Products: SRG-400

Serial Range: Beginning with G4001002 - Relay board change

Beginning with G4001007 - Terminal block assembly change

Release Date: January 21, 2019

Terminal Block Assembly (only 120v versions, 230v versions will remain the same)

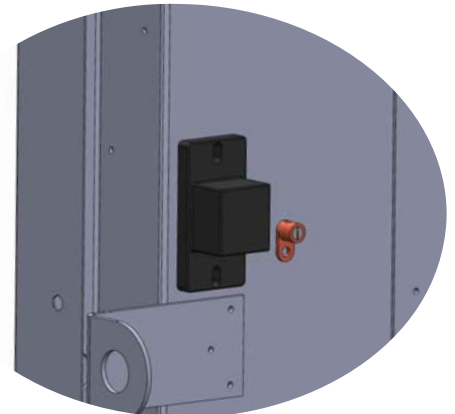
The bracket for the terminal block and ground lug is being eliminated and the terminal block and ground lug will be mounted directly to the service bay liner of the smoker.
